**GENERAL PLAN of MASONRY
FOR HIGHWAY BRIDGE at ALBANY AVE.
OVER TRACKS of
CENTRAL NEW ENGLAND RAILROAD CO.**

OFFICE OF CITY ENGINEER
HARTFORD CONN.
Date May 1905. Day Book No. 01701

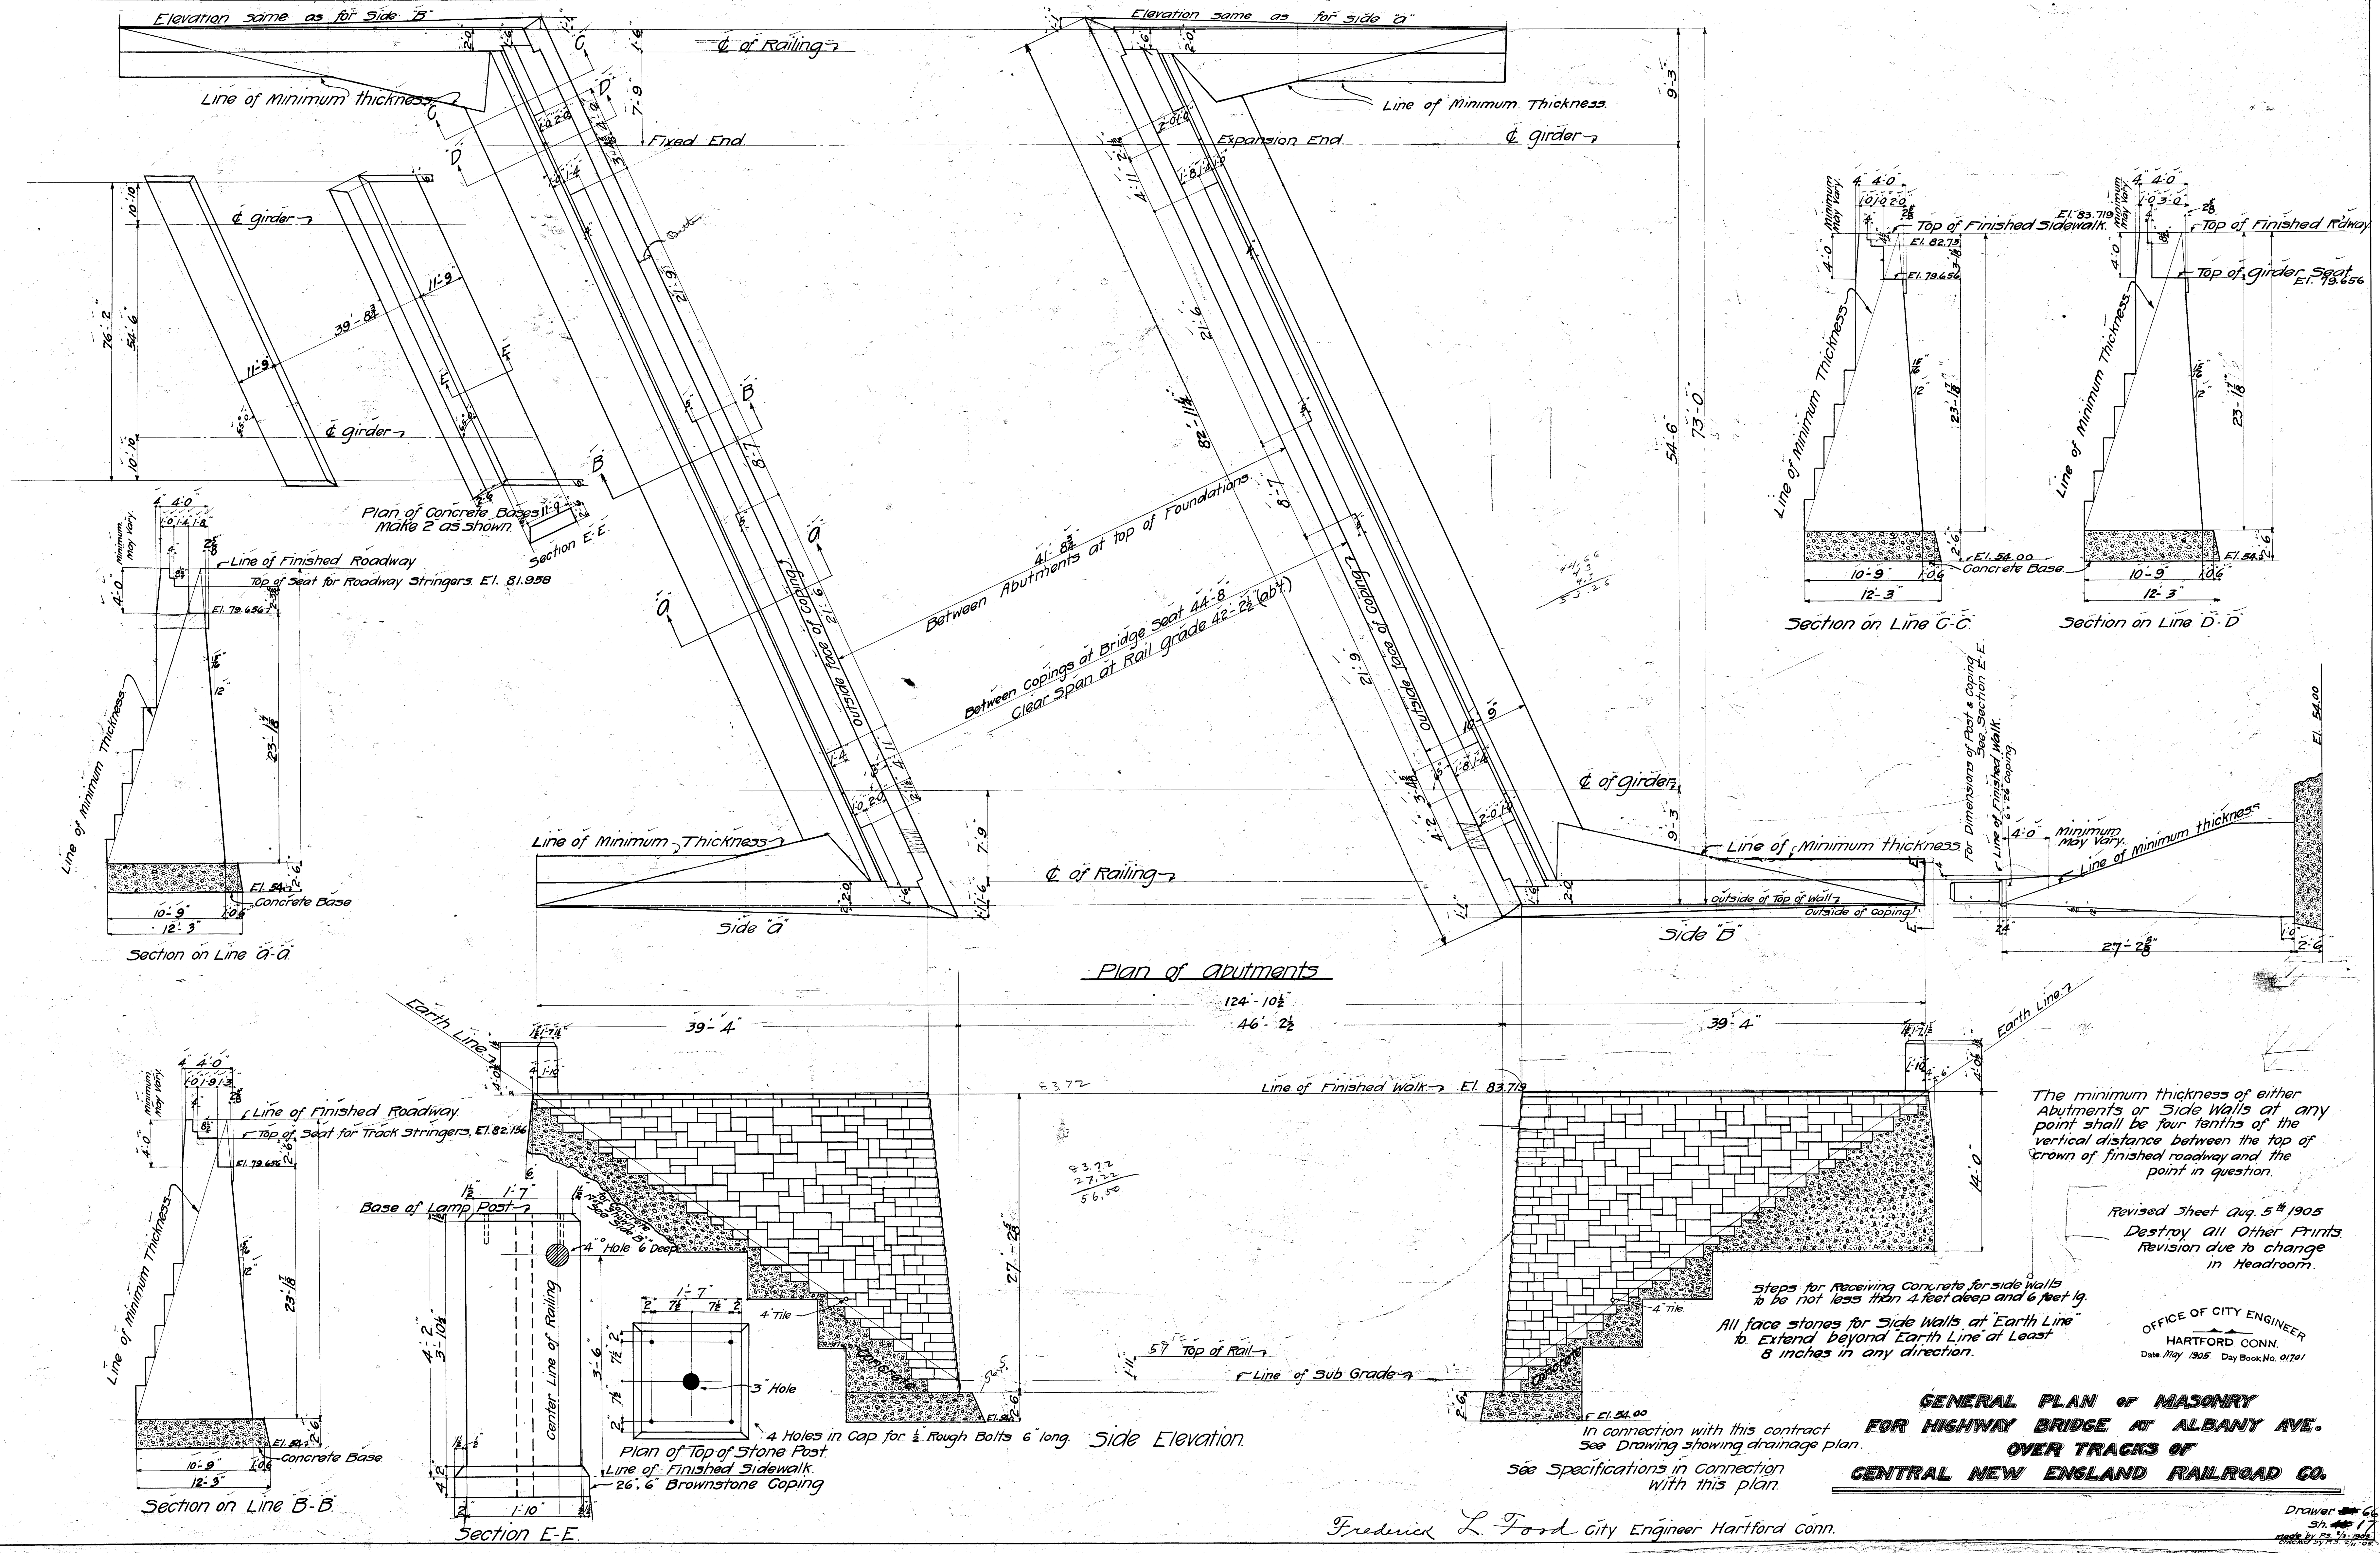
Revised Sheet Aug. 5th 1905
Destroy all other Prints
Revision due to change
in Headroom.
